PROPOSED SITE IMPROVEMENTS  
TO  
SHELL GAS STATION

375 MAIN STREET  
ARMONK, NY

September 14, 2020  
**VIA E-MAIL**

Re: ***375 Main Street – Site Plan Approval  
Section 108.03, Block 1, Lot 75***

DRAWING TITLE:  
**PROPOSED GRADING, DRAINAGE & UTILITY PLAN**

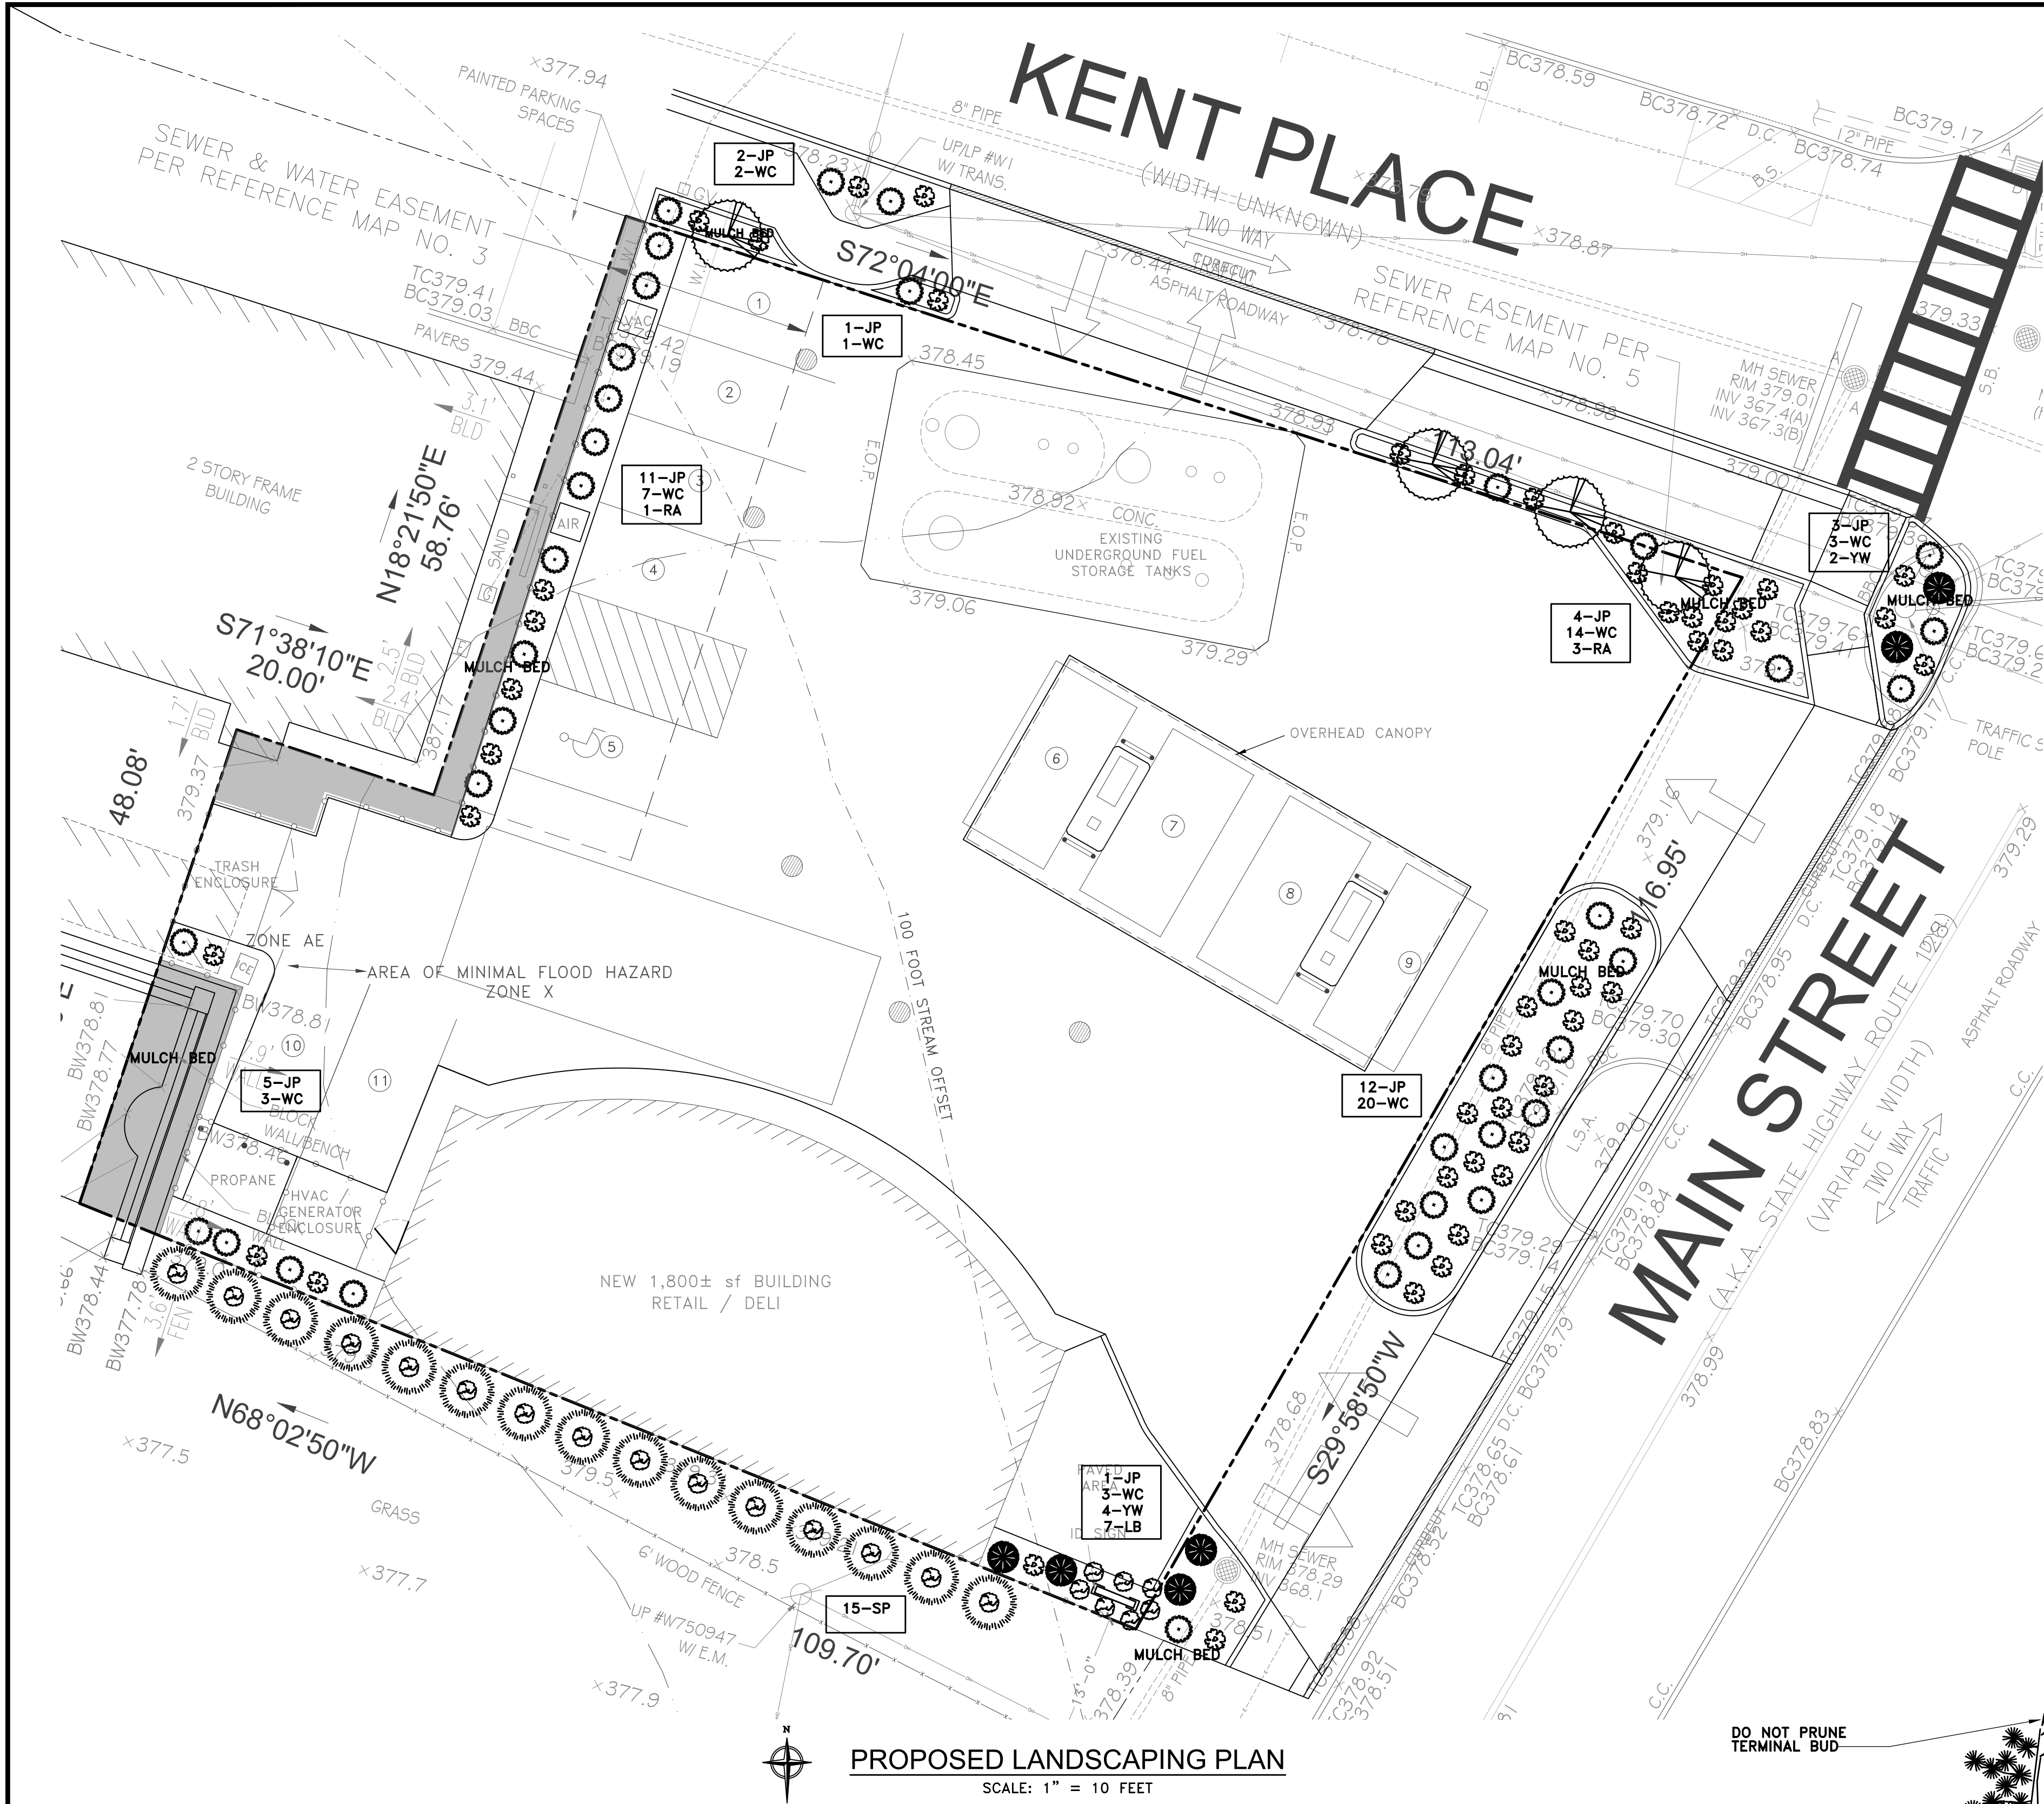
The Applicant has revised the proposed drainage plan to accommodate retention of up to the 100 year storm event. The system has an overflow to the existing storm sewer in Kent Place. The site grading is set to pitch all surface runoff towards drain inlets. This will be a marked improvement over the existing uncontrolled conditions on the site.

DRAWING TITLE:  
**PROPOSED LIGHTING  
PLAN**

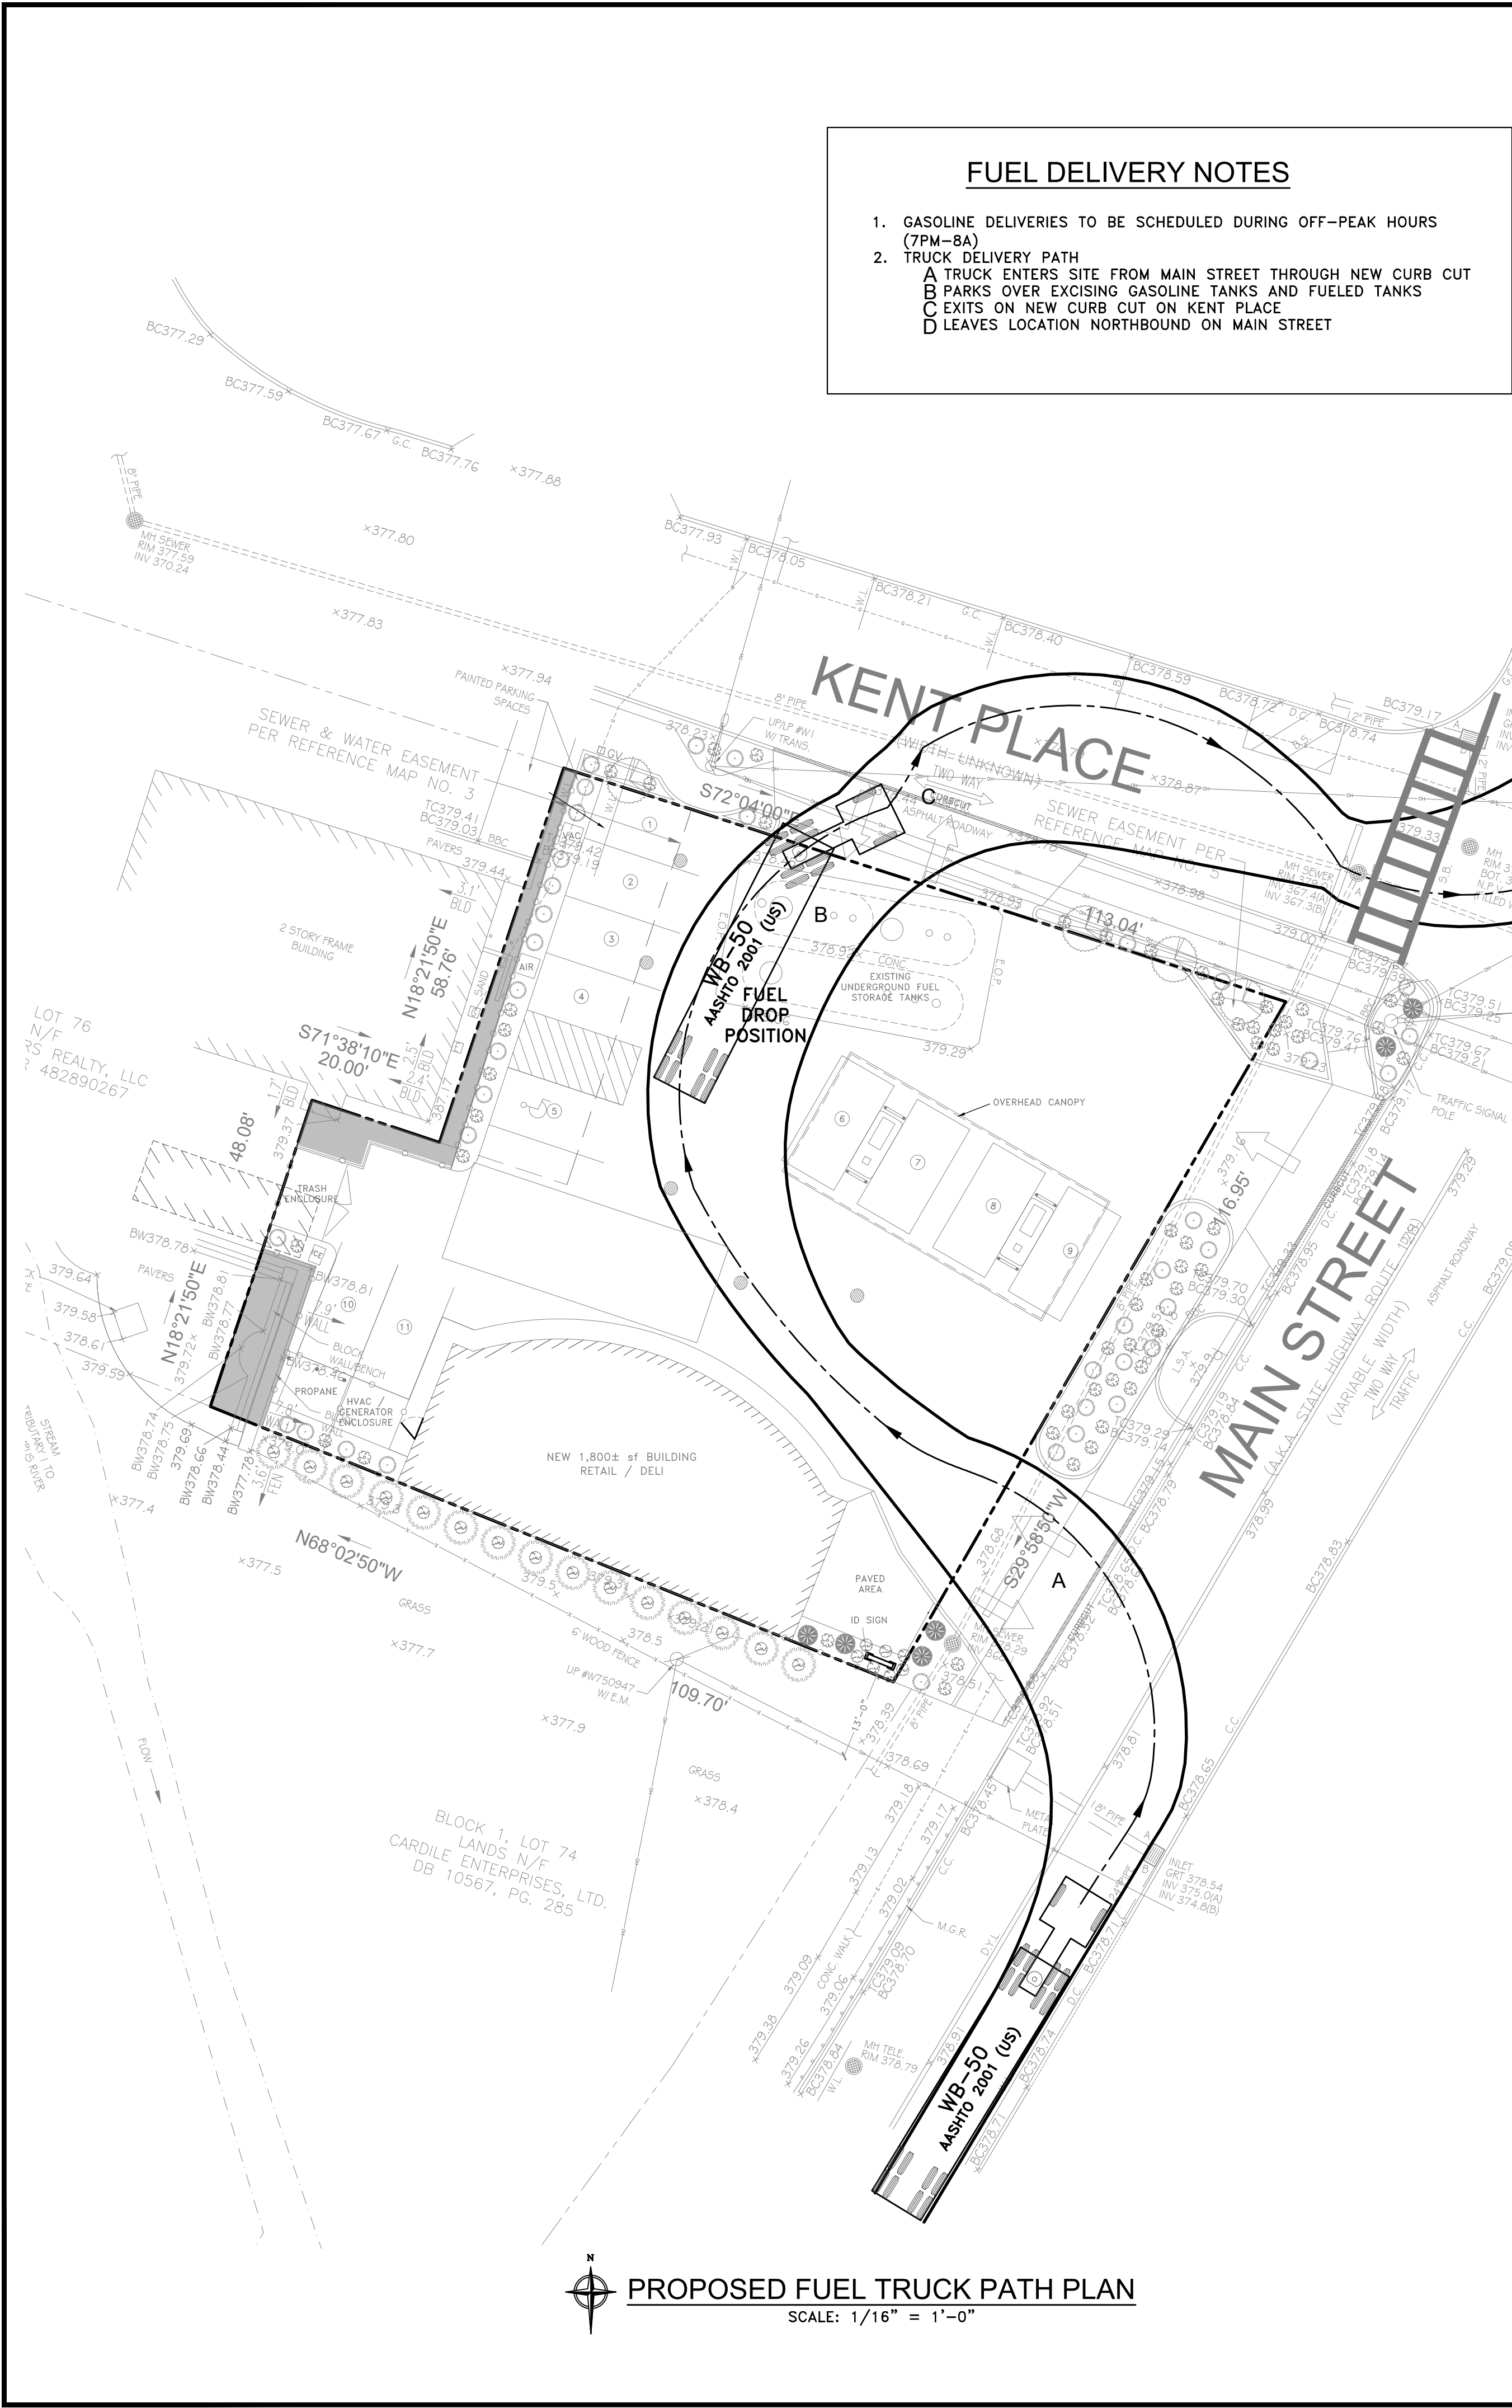
The site lighting plan has been revised to provide a maximum of 0.5 FTC at the property boundaries and an average of 12 FTC under the canopy. The plan set now includes a detail sheet of all the proposed site lighting fixtures, all of which will be downward facing shielded LED fixtures.

DRAWING TITLE:  
**PROPOSED FUEL  
TRUCK PATH PLAN**

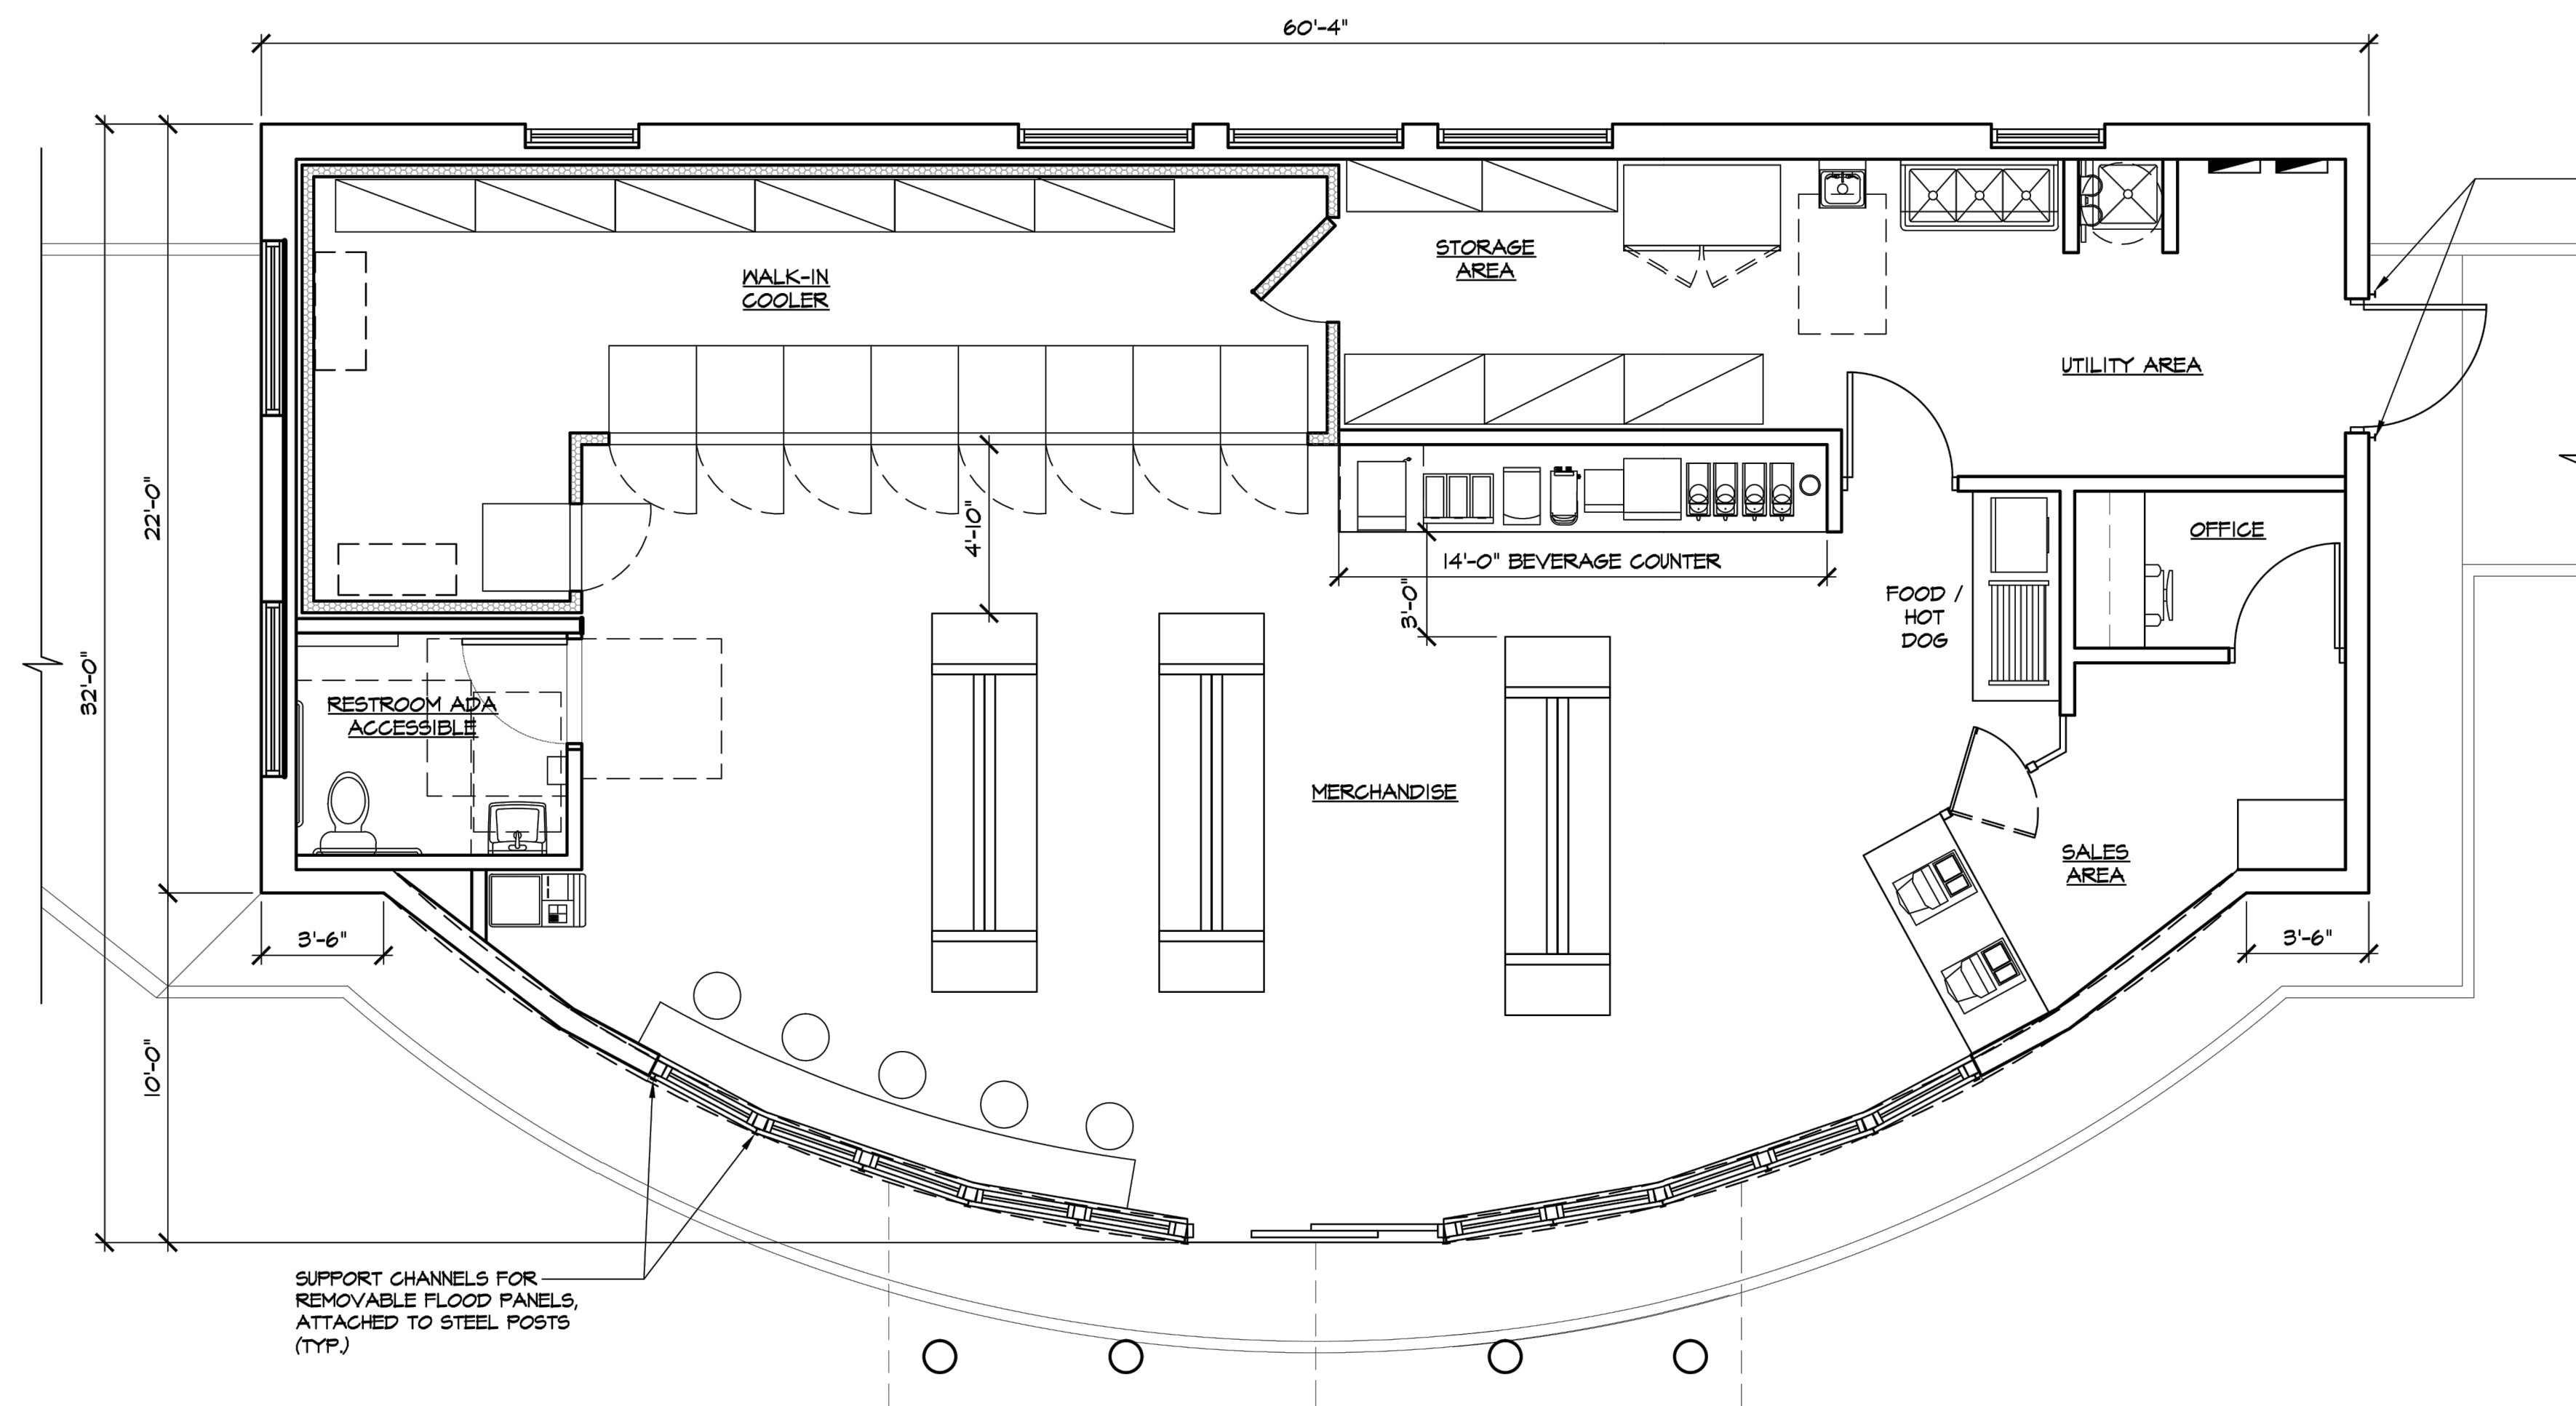
As requested by the Town's traffic consultant, STOP signs and STOP bars have been added to the site plan at all driveways and all other traffic signage is now shown on the plans. A proposed sight line plan has been added to Drawing No. C-007.00. As can be seen there are unobstructed sight lines for a minimum of 390 feet in either direction along Main Street. To that end, the applicant agrees to maintain the proposed landscaping along the Main Street frontage at a maximum height of three feet. An application has been made to NYSDOT for improvements in the State right-of-way, including landscaping.
